## UNITED STATES DEPARTMENT OF THE INTERIOR BUREAU OF LAND MANAGEMENT

## SUNDRY NOTICES AND REPORTS ON WELLS

SUBMIT IN TRIPLICATE- Other instructions on reverse side.  1 Type of Well Oil Well Oil Well Other  2 Name of Operator BOPCO, L. P.  3a Address P. O. Box 2760, Midland, TX 79702  3b. Phone No (include area code) 432-683-2277	7. If Unit or CA/Agreement, Name and/or No. NMNM71016X  8. Well Name and No. Poker Lake Unit #337II  9. API Well No. 30-015-39691					
2 Name of Operator BOPCO, L. P.  3a Address  3b. Phone No (include area code)	8. Well Name and No.  Poker Lake Unit #337II  9. API Well No.  30-015-39691					
3a Address 3b. Phone No (include area code)	9. API Well No. 30-015-39691					
,						
	30-015-39691  10. Field and Pool, or Exploratory Area

## Co-Flex line Conditions of Approval

## Internal Hydrostatic Test Report

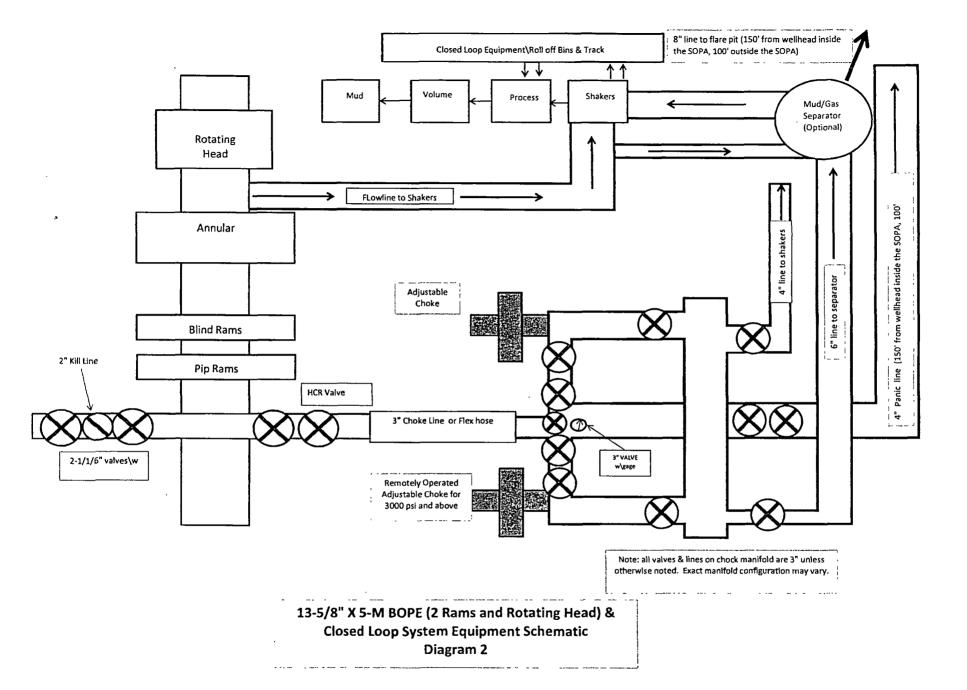
Variance approved to use flex line from BOP to choke manifold. Check condition of flexible line from BOP to choke manifold, replace if exterior is damaged or if line fails test. Line to be as straight as possible with no hard bends and is to be anchored according to Manufacturer's requirements. The flexible hose can be exchanged with a hose of equal size and equal or greater pressure rating. Anchor requirements, specification sheet and hydrostatic pressure test certification matching the hose in service, to be onsite for review. If the BLM inspector questions the straightness of the hose, a BLM engineer will be contacted and will review in the field or via picture supplied by inspector to determine if changes are required (operator shall expect delays if this occurs).
